Concerns regarding the clock model used in 60802 time synchronization simulations

**December 21, 2020
IEC/IEEE 60802 Joint Project Call**

Jordon Woods, Analog Devices

Temperature Effects

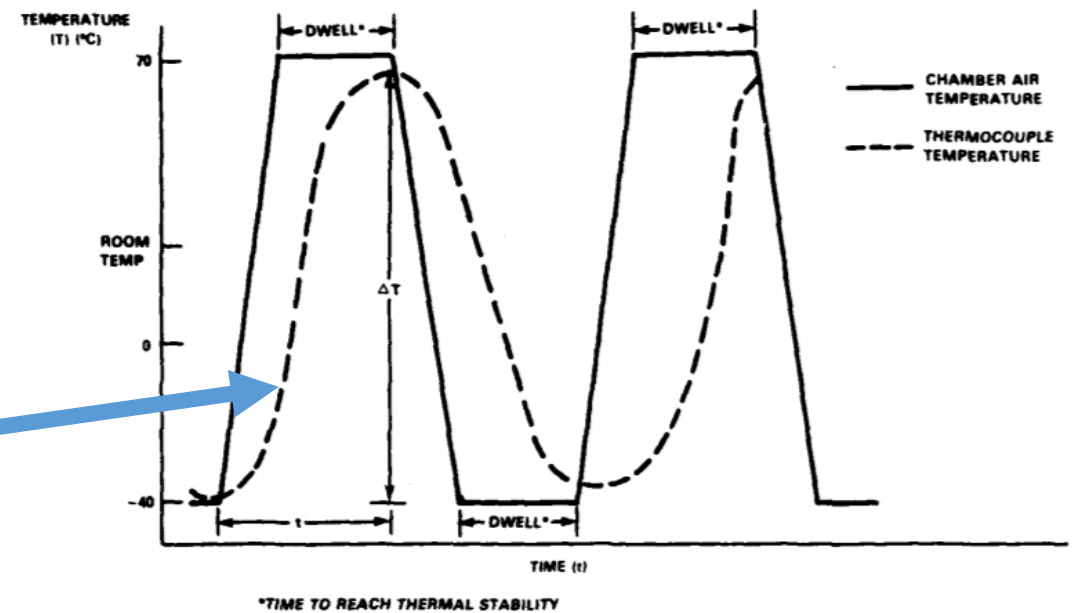
- At 85 C, $f = 24995500 \text{ Hz}$; difference from f_0 : 4500 Hz or 180 ppm
- At -40 C, $f = 24994718.75 \text{ Hz}$; difference from f_0 : 19531.25 Hz or 211 ppm

- Frequency error of the local clock should not be modeled as a function of time
 - No such specifications in oscillator data sheet.
 - Not representative of oscillator behavior.
- Frequency error should be dependent upon temperature with representative values for T , T_0 , f_0 and TC .
- A representative thermal profile should be selected to form the basis for modeling frequency error.

- Develop a frequency stability model for the local clock that depends on temperature
 - Calculate f based upon the enclosed formula or a suitable alternative.
 - Randomly assign f_0 based upon frequency tolerance rather than frequency stability.
 - Choose representative values for T_0 (25 C), and TC (0.050 ppm/°C²)
 - Some datasheets provide TC , others may list Frequency stability across temperature, still others are silent.
 - Select a representative thermal profile/cycle (e.g., -40 to +85 C; 25 C/min w/ 5-minute soak yields a period of 20 minutes).
 - Run single iterations of cases 1, 2, and 3 from the November simulations with timestamp granularities of 2, 4, and 8 ns (<https://www.ieee802.org/1/files/public/docs2020/60802-garner-further-simulation-results-time-sync-transport-1120-v02.pdf>).
